PROPOSED EXTENSION TO HOUSE SHOWER ROOM, STUDY AND UTILITY ROOM, PROVIDE SUN LOUNGE, AND PORCH TO FRONT	
PROJECT	
PROPOSED SINGLE STOREY EXTENSION TO 51 HEOL Y NANT BAGLAIN PORT TALBOT SALIZZER FOR CHRISTIANIA LLOYD	
DRAWING	
to be read in conjunction with IL20-200-01C	
DRG. No.	IL20-200-02B
REVISION	Rev B - Amended extension and roof details
SCALE	DATE
- 1:50	26/03/20

Superseded

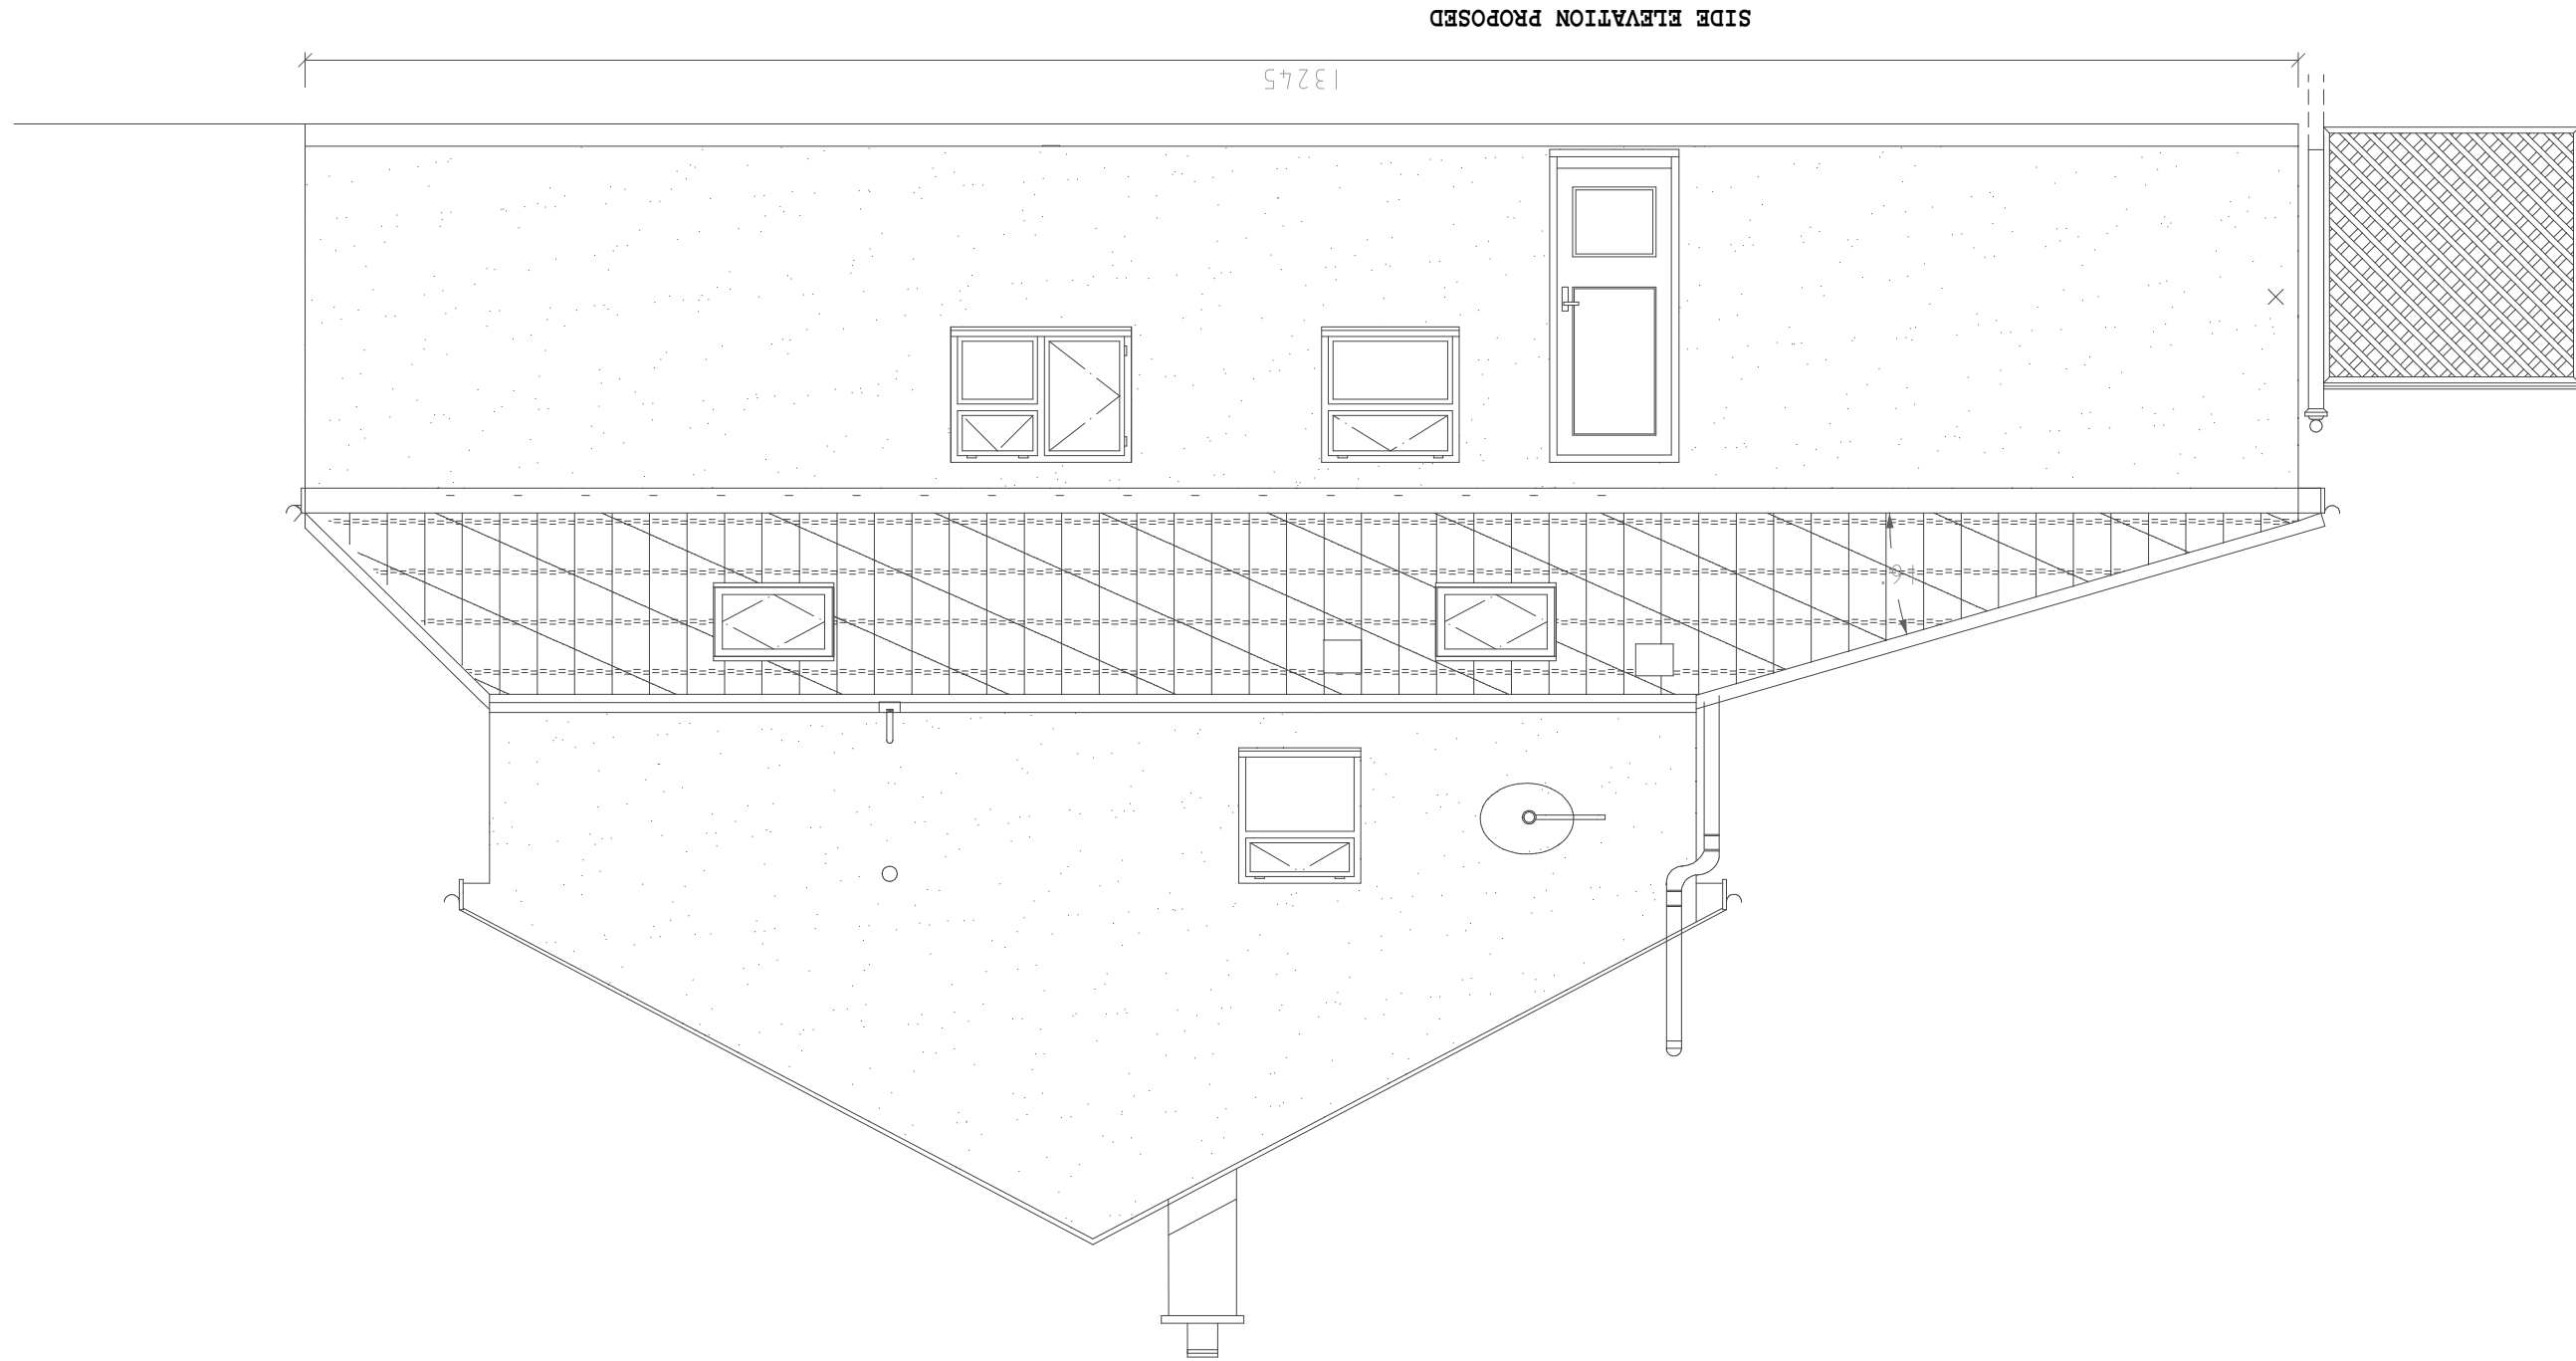
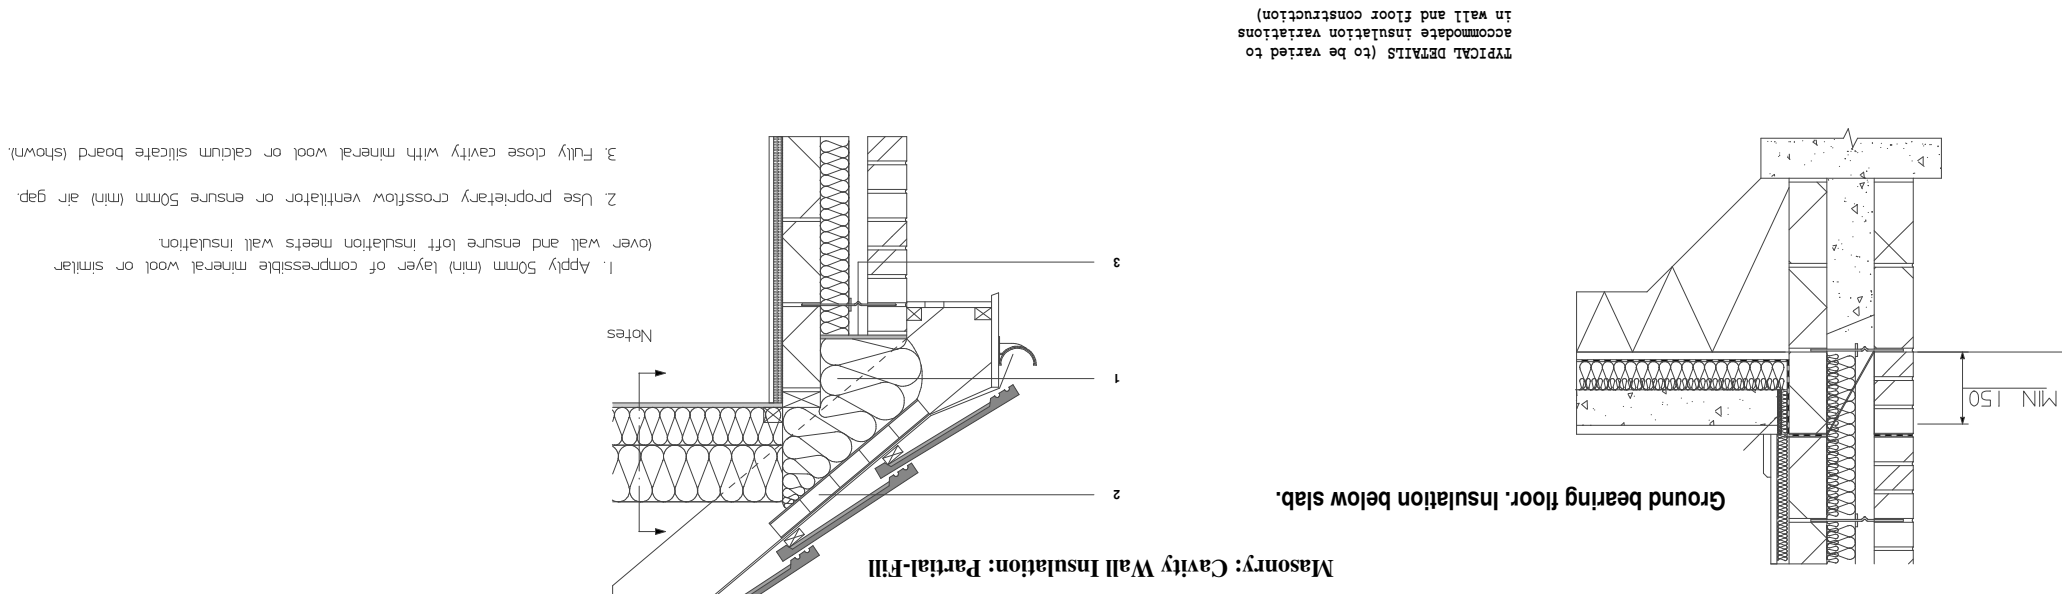
Take out window and sill to
make bedroom build up sill
to match main bathroom sill
Chick to enable pitch roof
at 16" to enable raised roof
panes to be fitted in line
Check roof pitch of 16"
achieved to below bedroom
area, existing ventilation
to roof.
Design to be fully in
accordance with structural
engineers calculations for all
structural support including
beams, hip rafters, foundations
and piers
